**Biology Committee Final Webinar Summary, September 30, 2016
Briefing on Green River Canal Screen for Biology Committee**

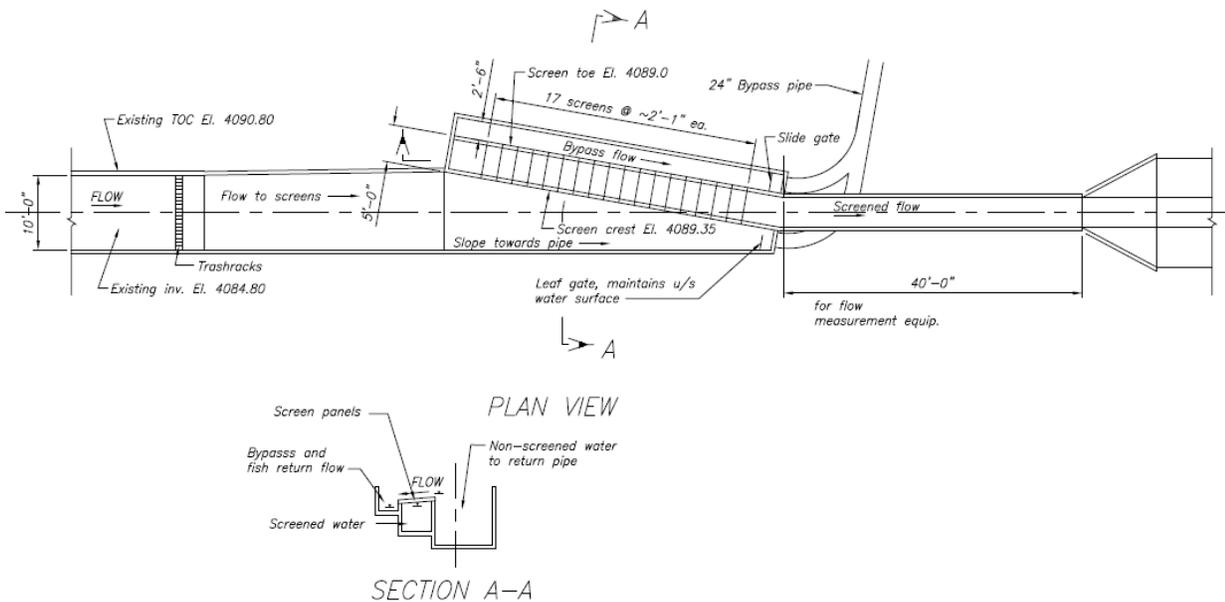
Kevin McAbee asked why the weir wall’s bypass pipe goes under the canal, rather than a “mirror image” layout which would allow the weir wall return flow to run unimpeded to the river. Mark said one of the two bypass flows would always have to go under the canal. Kevin said he thinks the smaller volume of water should be bypassed under the canal. Mark said they will consider this and whether it would work from a hydraulic perspective. Kevin said he thinks the canal owners will be very pleased with how this design will remove debris.

Brent noted this design has no screen bypass, meaning that if the screen did clog, it likely would receive immediate attention to maintain flow in the canal. Dave asked if floating debris might pile up against the bypass pipe; Mark and Bob didn’t think so.

Melissa asked if the outside trough edge in section A-A (carrying water, debris, and fish returned from over the screens) would be high enough to prevent fish (especially bonytail) from flipping out the top. Bob thought the wall would be ~2.5’ above the water depth and Melissa thought that would be adequate. Bob also asked for a recommendation from the committee on what a minimum depth would be. Tom Chart asked if there’s a difference in elevation in the two bypass pipes. Brent said they start at different elevations, but reach a common elevation where they join. Tom Chart wondered if there would be a velocity difference that could impact fish. Bob Norman said there could be small differences in velocity, but doesn’t think it would hurt the fish (in comparison to other velocities they survive). Bob said HDPE is a smooth-walled, pretty fish-friendly pipe, but noted they typically shave the inside seams, The diameter of these pipes may be too small to allow shaving, but Bob thinks the seams are smooth enough that it won’t be a problem.

The Committee discussed the trough (labeled Bypass Flow in the drawing) dimensions. Perhaps it needs to be narrower and deeper as opposed to 2' wide. Bob noted it will move slower as it's made deeper. The end of the channel has to be 30" inside diameter to connect to the return pipe. The depth hasn't been finalized and Reclamation would appreciate the Committee's input. Dave suggested a minimum of 10"-12". At that depth Bob thought the velocity might be about 6 cfs. Bob noted they plan to install a walkway above the bypass flow (will allow access for any needed maintenance/cleaning of the screens), and that also would limit bird predation.

Pete asked about the trash rack. Bob Norman said the openings will be ~6" with the hopes that any adult fish would make it through and be returned to the river. Bob didn't think large debris would go over the wall and screen. Pete thought it might be worth considering a trash rack with large openings near the bottom, but smaller openings near the surface. That should allow large fish to go through, but still catch large branches that could cause problems if they make it down to the bypass pipe.
